### **ADDENDUM NO. 3**

Date: **03/23/23**

Issued by: **Sacramento City Unified School District**

Project: **Project #0168-418 John D. Sloat ES Paving, Playground, and Fencing Project**

**DEMOLITION PLAN**

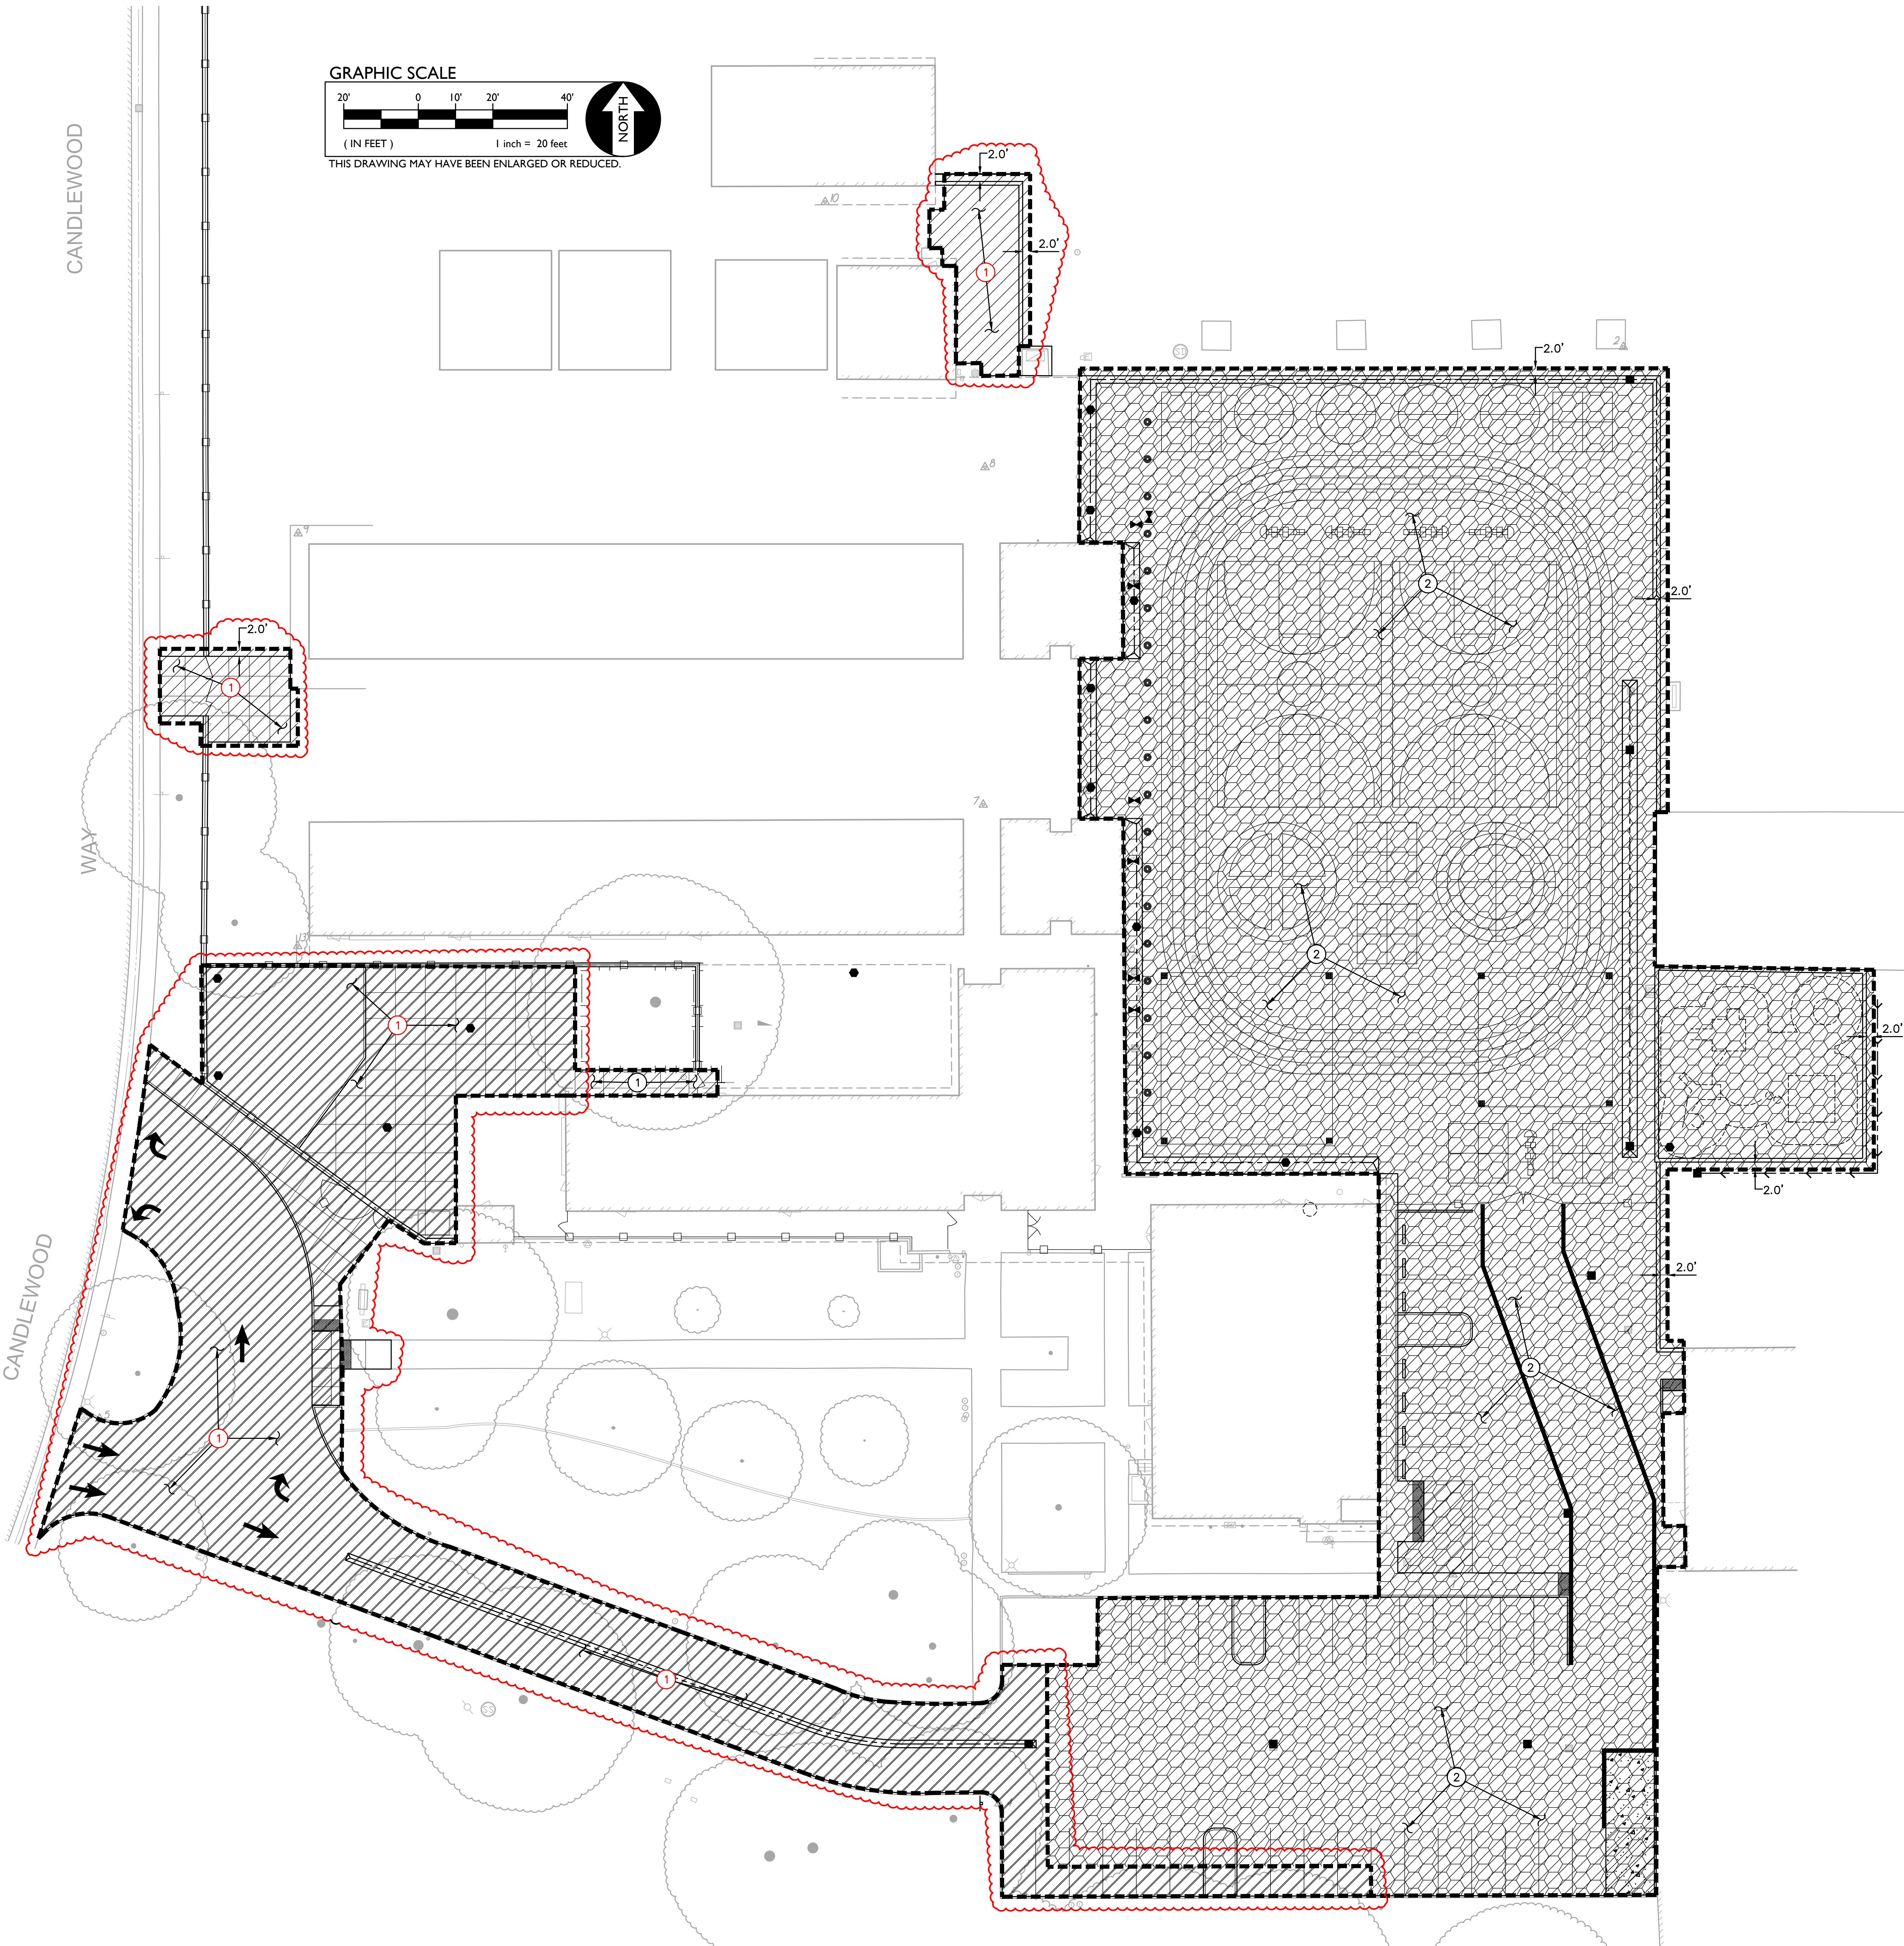
- AD03.03 Sheet C1.1 – Demolition Plan, Demolition Note 4: Refer to the attached **ADD1 C1.1**. All changes are clouded in red. Demolition Note 15 was added to the play structure on the north side of the site; Demolition Note 7 was duplicated in the Kindergarten Play Apparatus, to indicate removal of the entire play apparatus.

13. REMOVE AND DISPOSE OF EXISTING BOLLARD.
14. REMOVE AND RELOCATE SHED.
15. DEMOLISH APPARATUS CURB, RAMP, AND BARK EXISTING PLAY STRUCTURE TO BE RELOCATED (LOWERED, IN PLACE). REMOVE AND PROTECT ALL COMPONENTS TO BE REINSTALLED. DEMOLISH CONCRETE FOOTINGS FROM EMBEDDED COMPONENTS (OR REPLACE COMPONENTS). FILL AND COMPACT ALL FOOTING CAVITIES.

SHEET TITLE:  
**ENGINEERED FILL  
 PLAN**

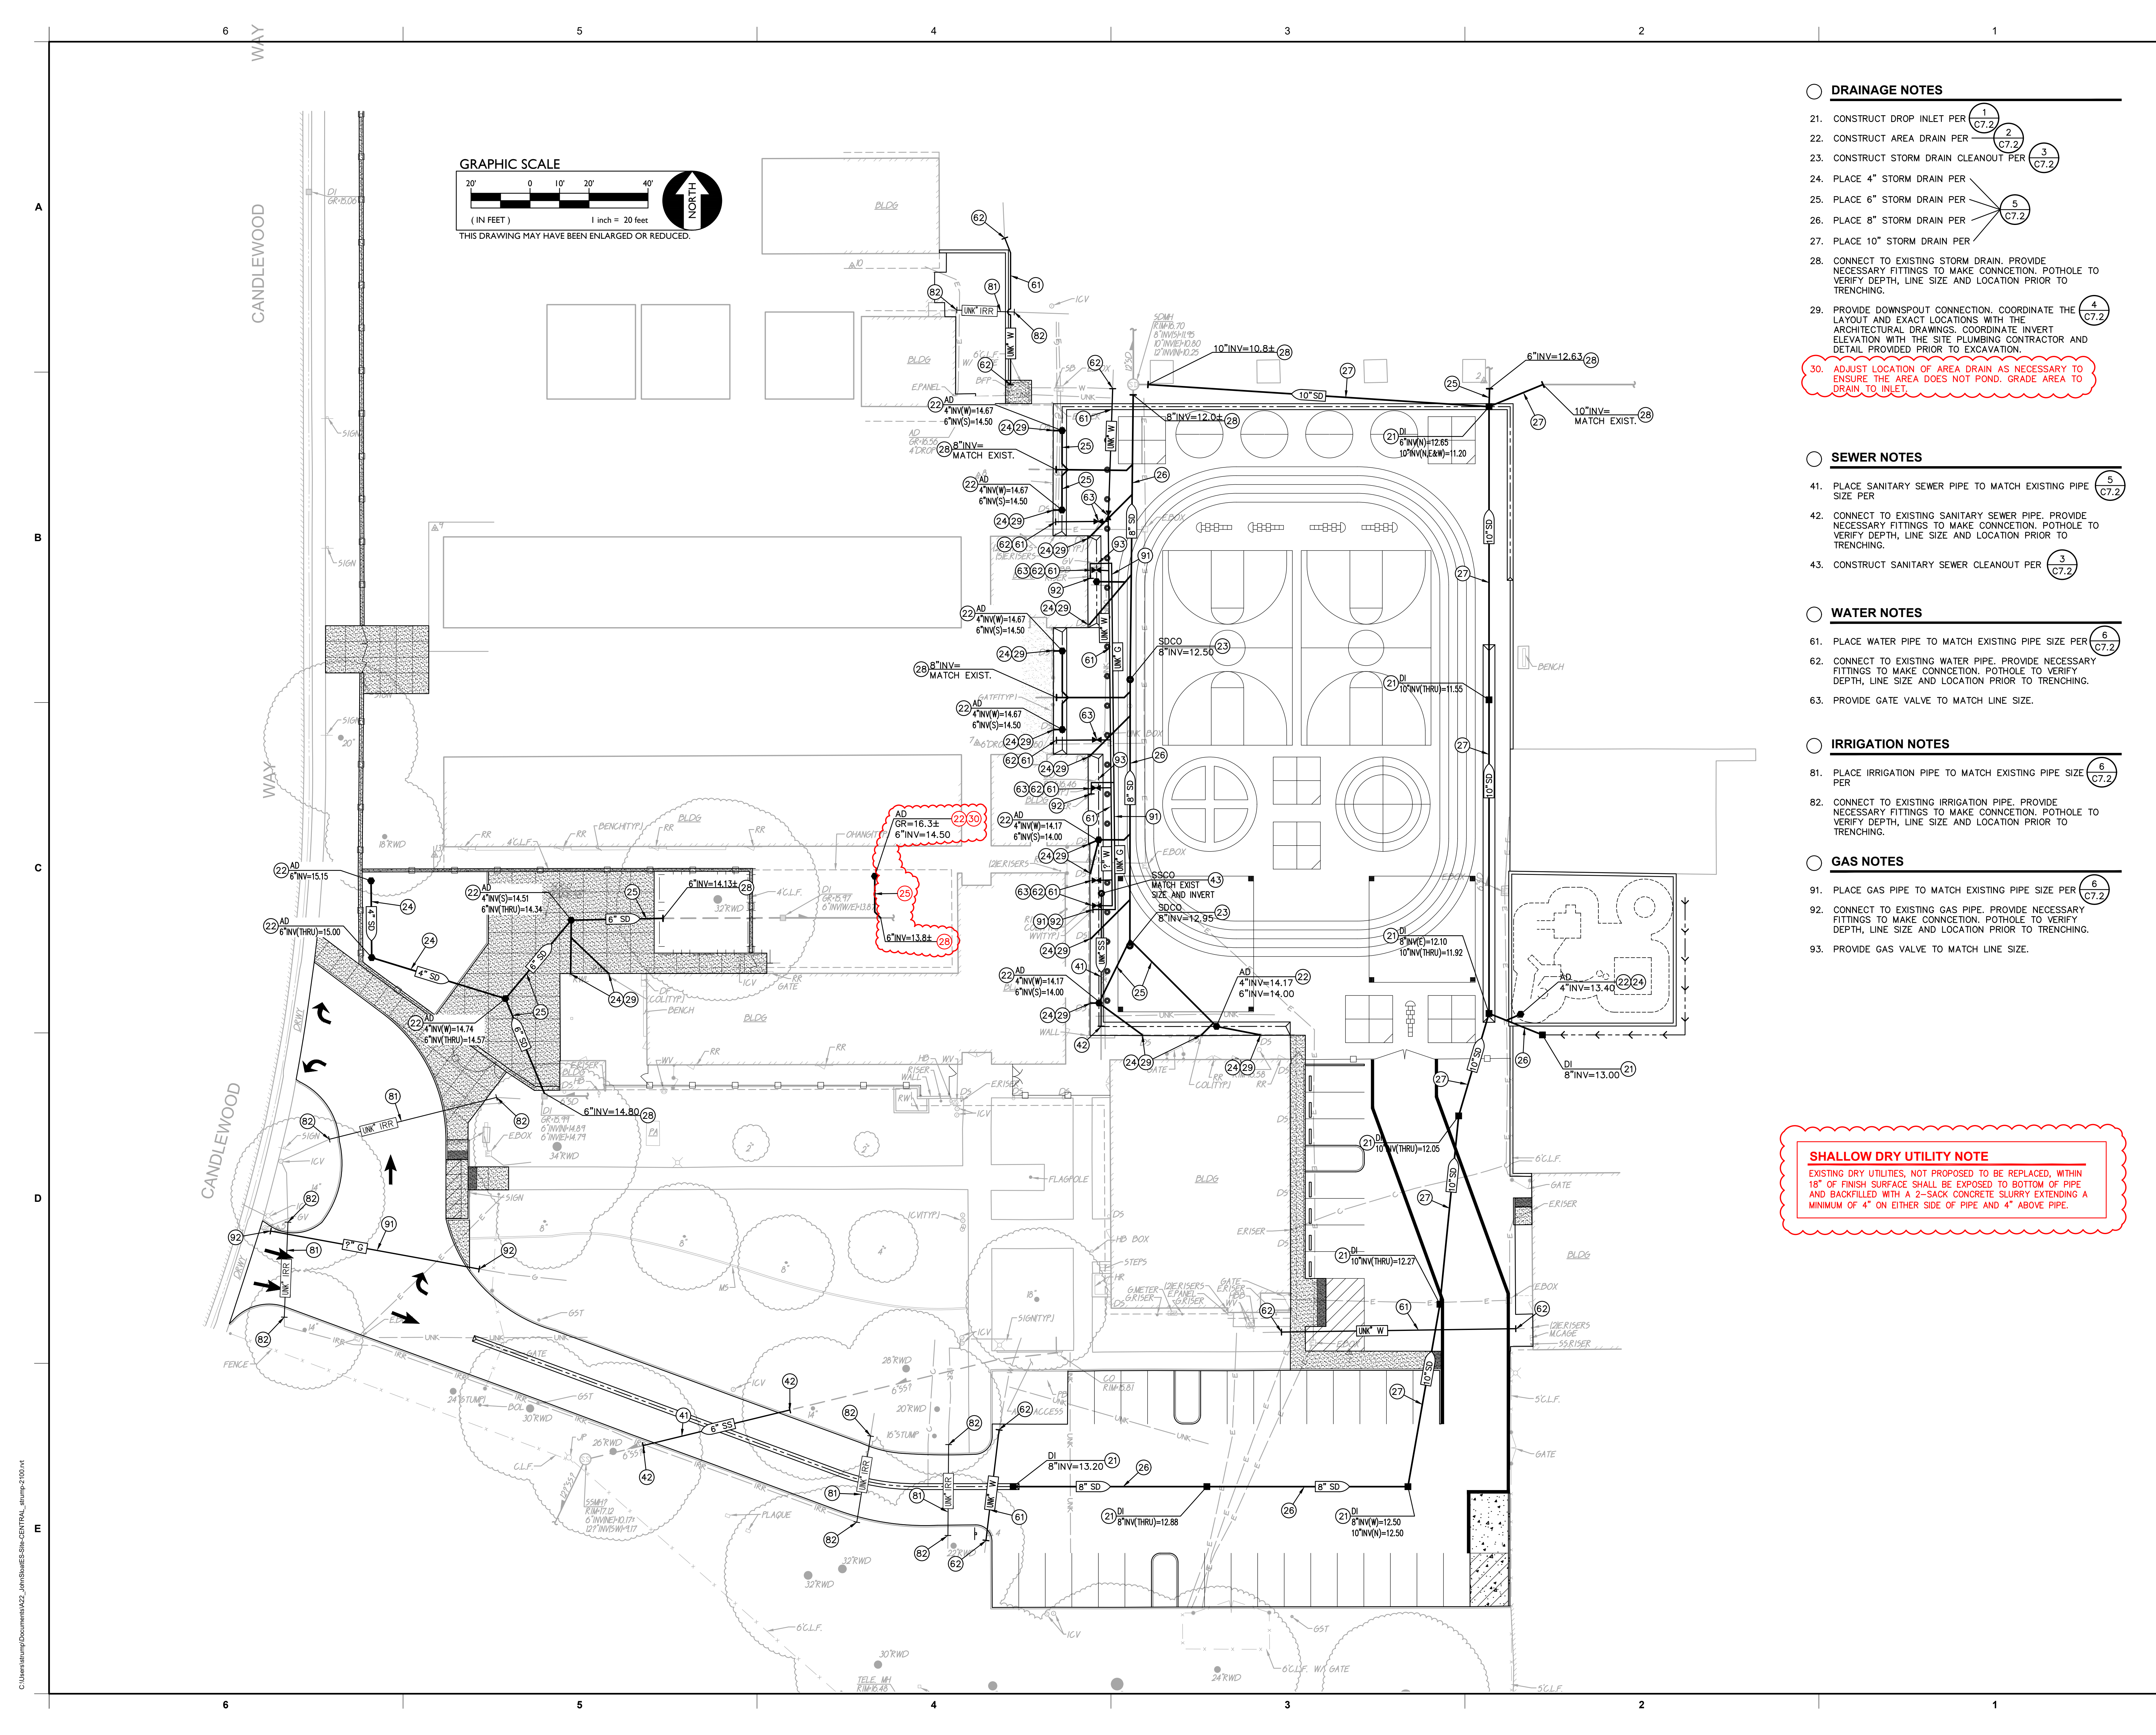
- AD03.04 Sheet C1.3 – Engineered Fill Plan: Replace with the attached **ADD3 C1.3**. All changes are clouded in red. Changes included are the removal of areas of lime treatment in two smaller areas and in the driveway from Candlewood Way to the parking lot due to trees adjacent to the driveway.

- Q10: The lime-treatment area noted on the engineered fill plan on sheet C1.3, doesn't match the areas required to be lime-treated by the paving plan on sheet 4.1. Please update the engineered fill or paving plan to confirm where lime-treatment is required by the project plans.  
A10: **Refer to response in Addendum # 3, above.**
